PLANNING, ZONING, & BUILDING DEPARTMENT
PZ&B Staff Memorandum: Architectural Commission (ARCOM)

SUBJECT: ARC-24-0034 (ZON-24-0020) 336 W AUSTRALIAN AVE W

MEETING: JULY 24, 2024

ARC-24-0034 (ZON-24-0020) 336 AUSTRALIAN AVE W (COMBO) - VARIANCES. The applicant, Sharon Handler Loeb, has filed an application requesting Architectural Commission review and approval for site wide landscape and hardscape modifications, installation of a generator and the relocation of pool equipment requiring variances. Town Council shall review the application as it pertains to zoning relief/approval.

PROPOSED SITE PLAN

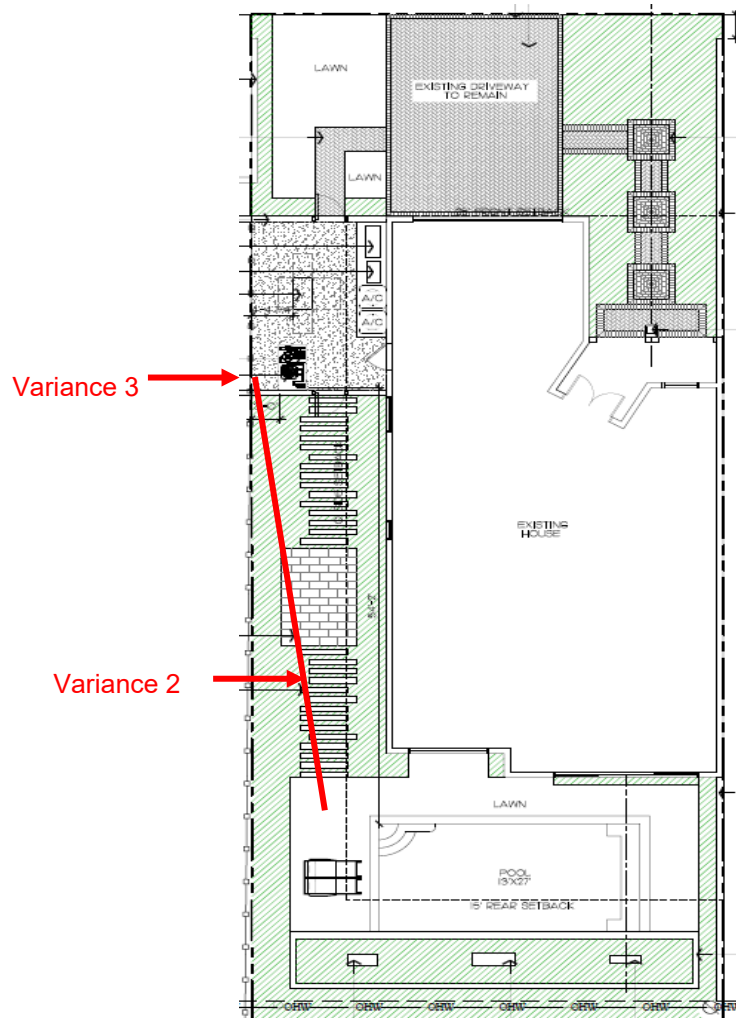
A preliminary review of the project indicates that the application, as proposed, is inconsistent with the Town zoning code and requires three (3) variances.

Code Section	Required	Proposed	Variance
Variance 1: Section 134-948	45% overall open space	36.35% LOS	8.65%
Variance 2: Section 134-1728(c)	Pool equipment @ 25'	54'-2"	29'-2"
Variance 3: Section 134-1728(c)	10' setback pool heater	3'	7'

The applicant is proposing renovations to hardscape and landscape to half of an attached duplex parcel, including the relocation of mechanical and pool equipment, which will require variances related to setback and distance separations. Additionally, the applicant is proposing to modify more

than 50% of the existing landscape open space area. The zoning code requires that landscape open space calculations be brought up to current requirements if altering 50% of the existing landscape area. Although the applicant is proposing an improvement from existing conditions (36.35% proposed in lieu of the 26.74% existing), a variance is required for failure to meet the 45% minimum required. Although the applicant is proposing an improvement from existing conditions (36.35% proposed in lieu of the 26.74% existing), a variance is required for failure to meet the 45% minimum landscape open space required.

The proposed pool equipment location is within the required setback (variance #3) and spaced further than permitted from the edge of the water (variance #2).
